Groundwater Transfer Review Summary Form

Transfer/PA # T- 14561 (RA)

Application: T-14561

Applicant Name: Orchard Heights Water Assoc.

Well Construction Cross-Section**Beeson and Tolan (2001) B-B' Cross-Section**

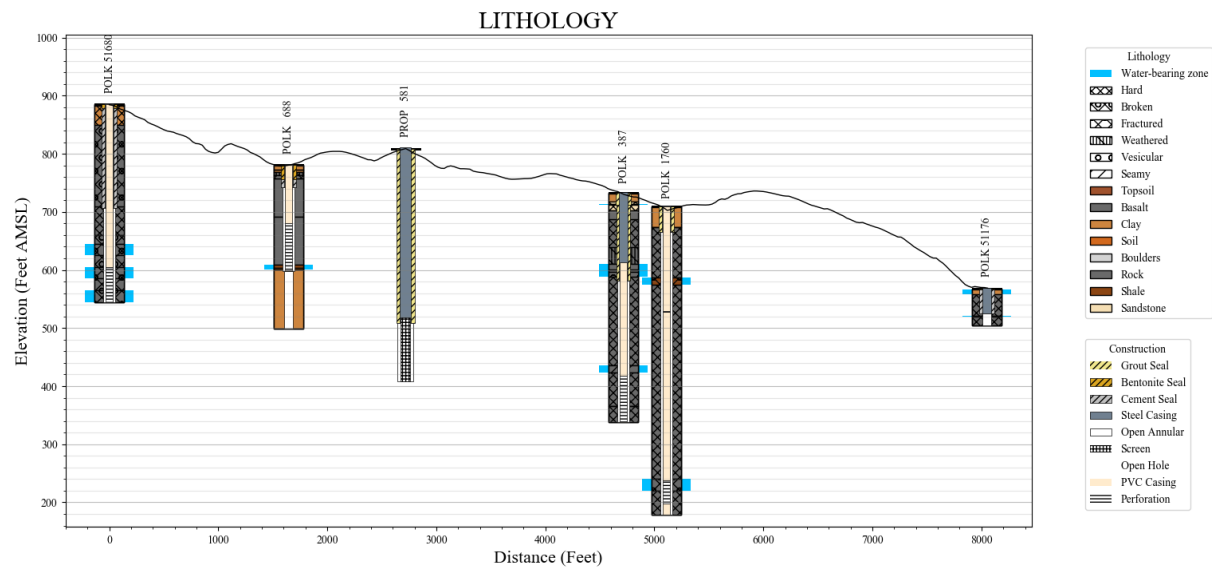
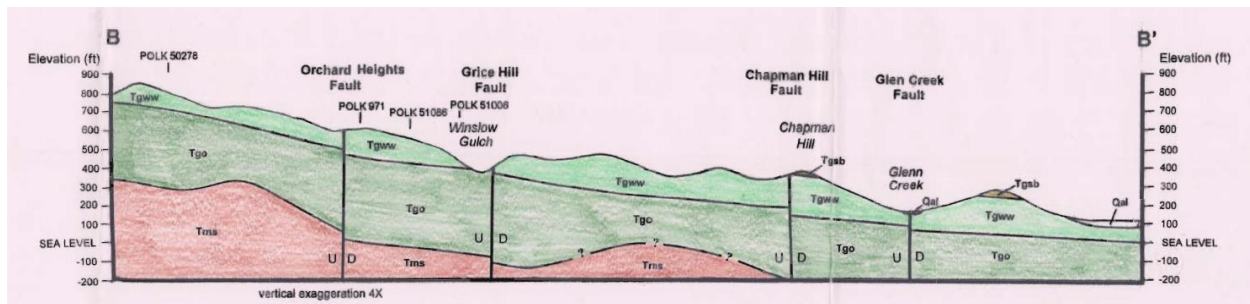
☒ Yes ☐ No Comments: The nearest neighboring well to the proposed APOA is POLK 688, ~1,070 ft north of the APOA and ~2,950 ft south of the authorized POA. Although the deepest water-bearing zone noted in POLK 688 (172-180 ft bls [~609-601 ft msl]) is above the proposed open interval of the APOA, the bottom of POLK 688 (282 ft bls [~499 ft msl]) is coincident with the proposed open interval of the APOA (see attached Well Construction Cross-Section). Furthermore, POLK 688 fully penetrates the basalt aquifer system at its location and extends ~110 ft into the underlying marine sedimentary bedrock, with its noted water bearing zone occurring at the apparent contact between the Columbia River Basalt Winter Water Member (Tgww) and the sedimentary bedrock (Tms). This contact appears to slope downward toward the south as evidenced by the mapped contact at ~700-710 ft msl (~100 ft above the elevation of the noted water-bearing zone in POLK 688) around Croft Reservoir and the much greater mapped thickness of the Columbia River Basalt to the south, with the Ortley Member (Tgo) mapped as present beneath the Winter Water Member around Glenn Creek but absent around Croft Reservoir (Beeson and Tolan, 2001). The sloped basalt-sedimentary contact likely is the result of the basalt having been emplaced upon the eroded and/or structurally-deformed topography of the sedimentary bedrock, since the contact between the Winter Water Member and the Ortley Member of the basalt appears to have a much more even grade and does not slope as steeply or in the same direction as the basalt-sedimentary contact, which is illustrated in the B-B' cross-section by Beeson and Tolan (2001) (attached). The water-bearing zone at the basalt-sedimentary contact in POLK 688 likely resulted from the rapid cooling and fracturing of the basalt as it was emplaced and, therefore, could be expected to exist at most (if not all) locations of basalt-sedimentary bedrock contact. Because of the expected near-ubiquity of the basalt-sedimentary contact water-bearing zone and its differing orientation from the interflow water-bearing zones within the basalt, these two types of water-bearing zones likely intersect at various locations throughout the area of interest. Therefore, hydraulic stresses from pumping groundwater in the basalt interflow water-bearing zones could be expected to propagate into the basalt-sedimentary contact water-bearing zones and vice versa. As such, it is likely that pumping the proposed APOA would likely cause interference with POLK 688 and, due to the proposed APOA's closer proximity to POLK 688 relative to the authorized POA, interference with POLK 688 would likely increase as a result of the proposed change.

Well-to-Well Interference Analysis – APOA to POLK 688

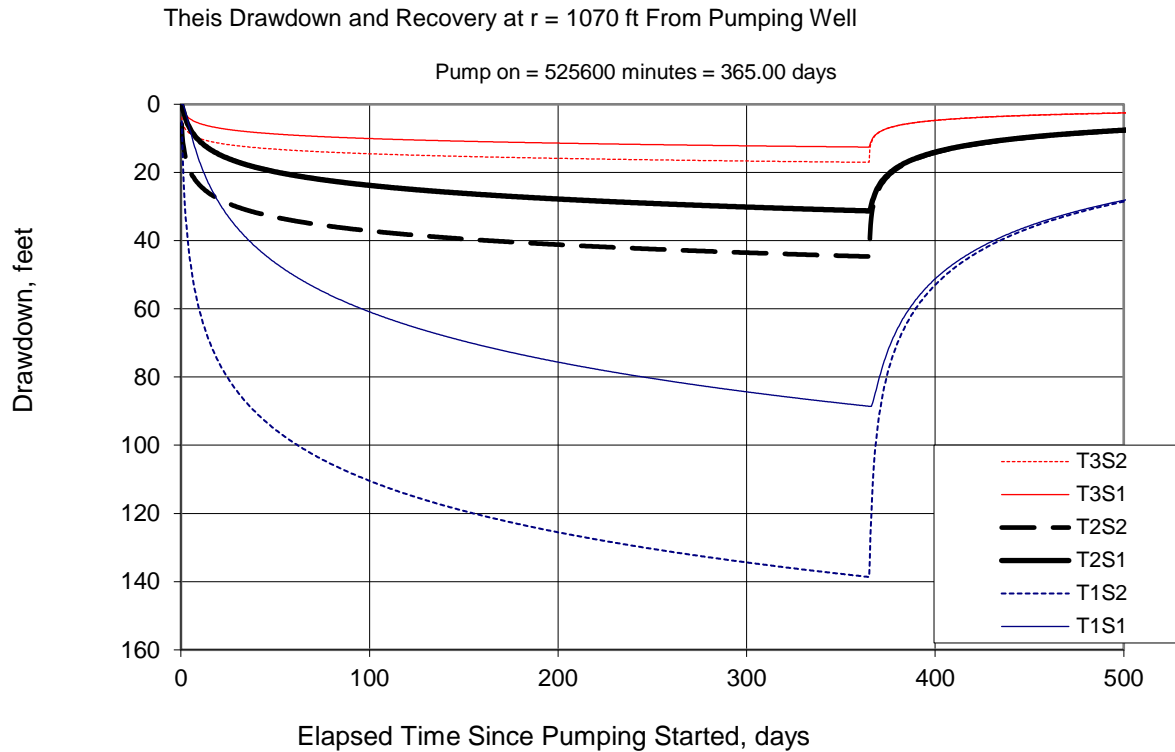
☐ Yes ☒ No If yes, explain: Potential interference with POLK 688 from the proposed APOA was analyzed using the Theis (1935) solution for drawdown in a confined aquifer (see attached Well-to-Well Interference Analysis). Results of the analysis indicate that, while interference with POLK 688 from the proposed APOA may be significant, it will not likely result in injury to POLK 688.

Pumping rate, $Q = 0.254$ cfs [maximum developable rate]

Pumping time, $t_{\text{pump}} = 365$ days [year-round]

Radial distance, $r = 1,070$ ft [approximate distance from proposed APOA to POLK 688]

Transmissivity: $T1 = 80 \text{ ft}^2/\text{day} \mid 300 \text{ ft}^2/\text{day} \mid 900 \text{ ft}^2/\text{day}$ [Estimated from water well report specific capacities via Vorhis (1979) method]

Storativity: $S1 = 0.001 \mid S = 0.0001$ [Conlon et al., 2005]

Estimated Available Water Column in POLK 688 = 256 ft = 26 ft bls [Static Water Level, 11/23/1994] – 282 ft bls [total well depth per water well report]
